V2500-A1 SERIES PROPULSION SYSTEMS SERVICE BULLETIN

This document transmits the Revision 1 of Service Bulletin V2500-ENG-72-0542 and the Revision 1 of the Supplement

V2500-ENG-72-0542

ENGINE – NEW FIRST STAGE DUCT SEGMENTS AND HPT VANE SUPPORT**1. Planning Information****A. Effectivity**

LOCATION OF THE STAGE 1 HIGH PRESSURE TURBINE SUPPORT ASSEMBLY
Figure 1

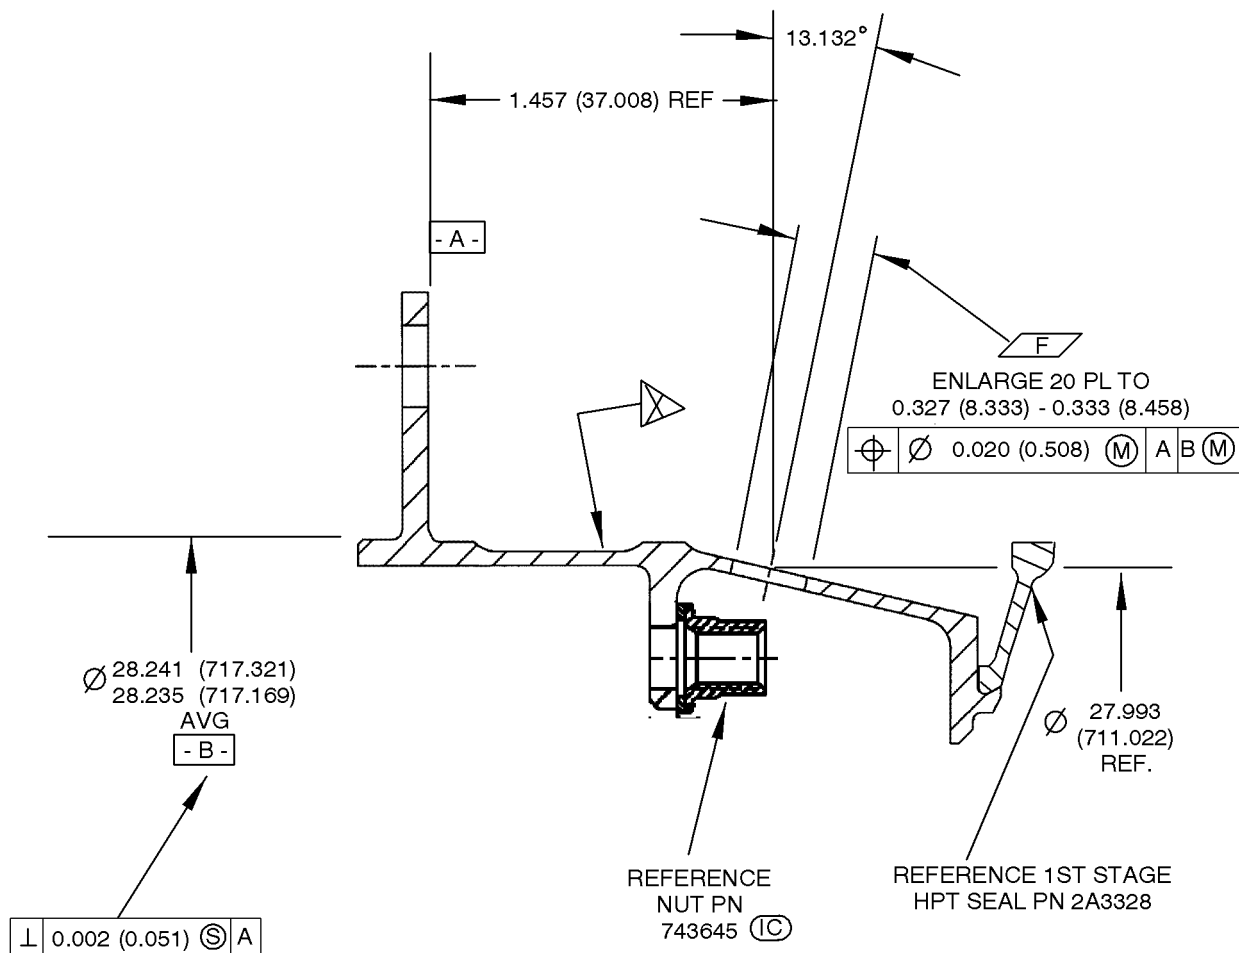
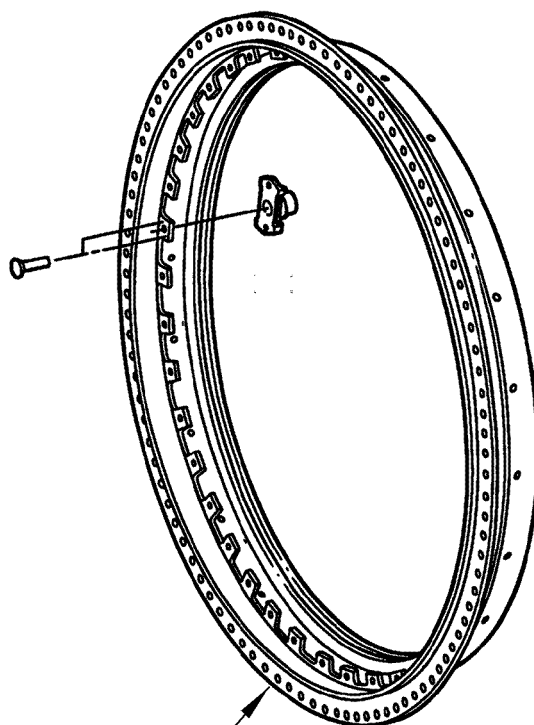
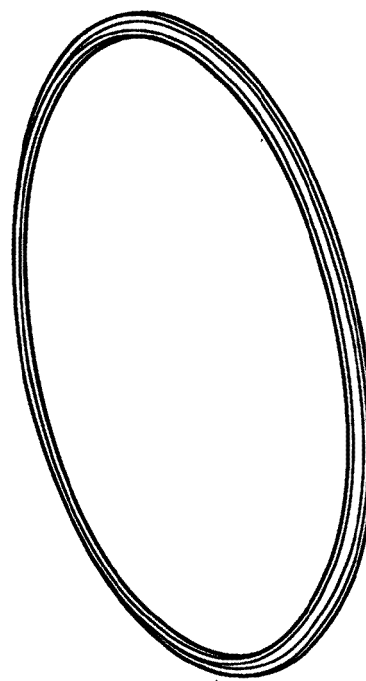
- (a) Do a modification of the Stage 1 HPT Support Assembly (72-44-10, 01-010), P/N 2A3360
 - (i) Remove the Stage 1 HPT Seal (72-44-10, 01-060), P/N 2A3328 (Refer to Figure 1 and 2).

INSTALL THE 2A4027 STAGE 1
HPT SUPPORT ASSEMBLY (1OFF)

USE THE 2A3328 STAGE 1
HPT SEAL (1OFF)

MODIFICATION OF P/N 2A3360 STAGE 1 HIGH PRESSURE TURBINE SUPPORT ASSEMBLY
Figure 2

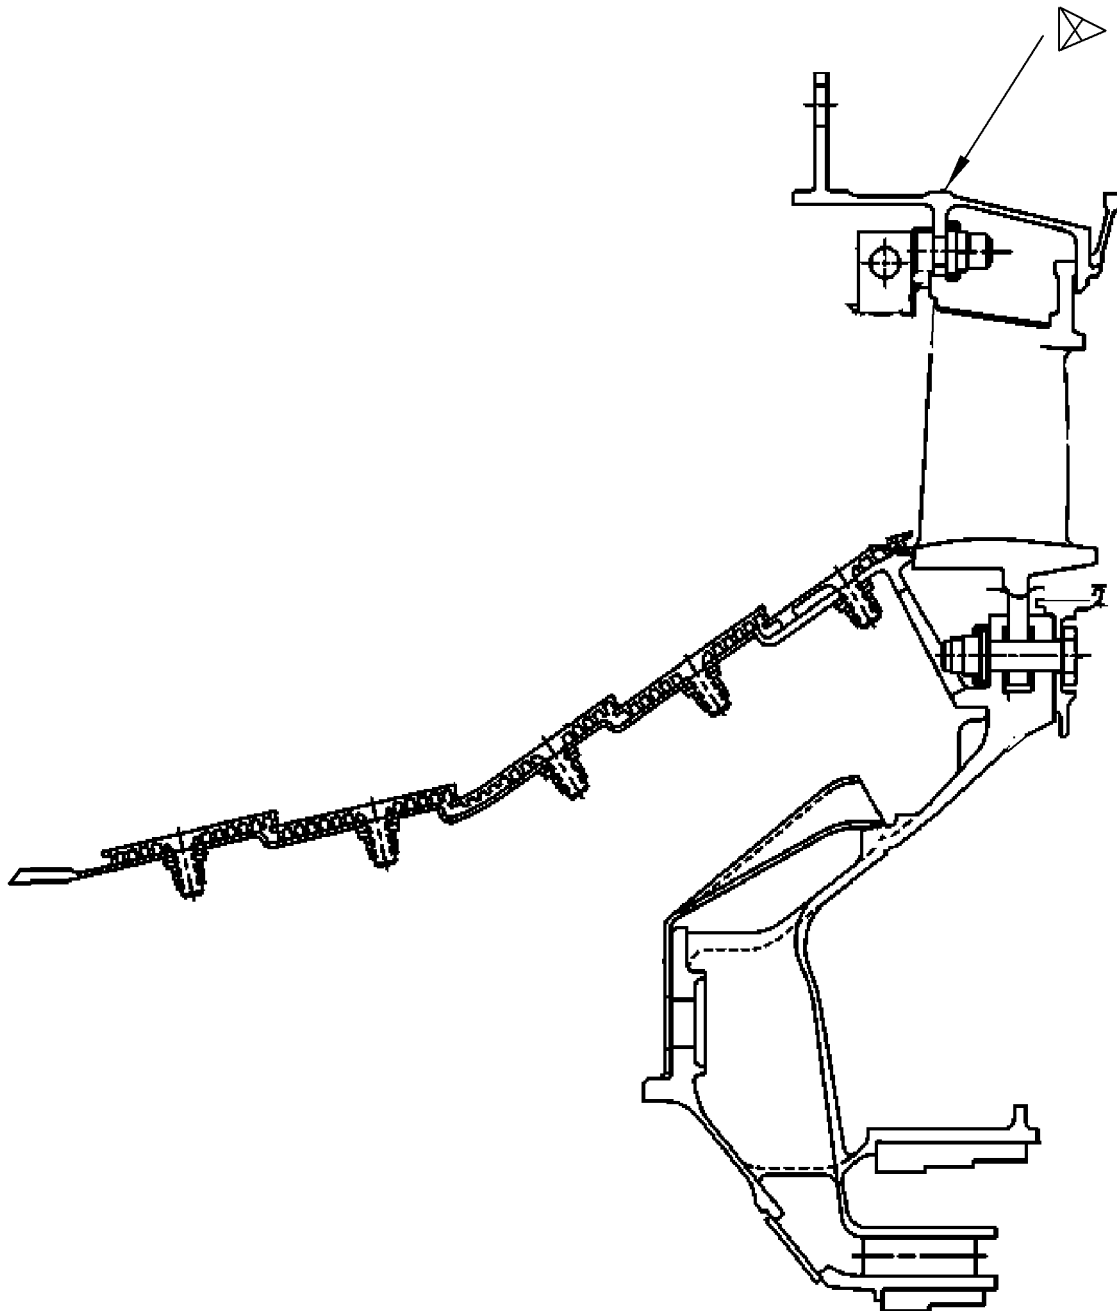
- (ii) It is recommended that the 40 nuts (72-44-10, 01-020), P/N 743645 be removed to avoid damage to the nuts during modification (Refer to Figure 2).

- (iii) Enlarge hole "F" 20 places in nonprocureable Stage 1 HPT Vane Support, P/N 2A3327 or P/N 2A1359-001 (Refer to Figure 2).
- (b) Mark the new part numbers on all affected parts. Use the Deep Electro Etch, Metal Stamping, or Vibration Peen method (Refer to Standard Practices/Process Manual, Chapter 70-09-00)

- (i) Identify nonprocureable Stage 1 HPT Vane Support old P/N 2A3327 as new P/N 2A3327-001 after modification (Refer to Figure 2)
 - OR
 - (ii) Identify nonprocureable Stage 1 HPT Vane Support old P/N 2A1359-001 as new P/N 2A1359-002 after modification (Refer to Figure 2).

- (iii) Identify Stage 1 HPT Support Assembly old P/N 2A3360 as new P/N 2A4027 after modification (Refer to Figure 2).
 - (iv) Identify the Turbine Nozzle Group old P/N 2A3800 as new P/N 2A4120 after modification (Refer to Figure 3).

MARKING LOCATION FOR TURBINE NOZZLE GROUP
Figure 3

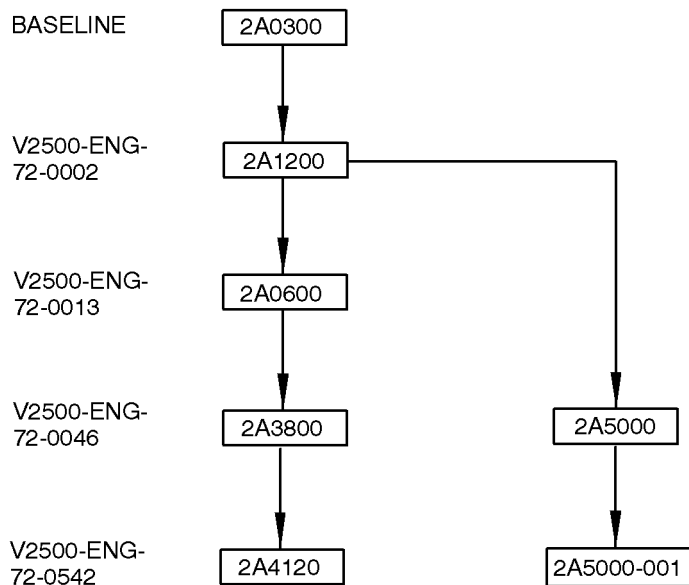
- OR
 - (v) Identify the Turbine Nozzle Group old P/N 2A5000 as P/N 2A5000-001 after modification (Refer to Figure 3).
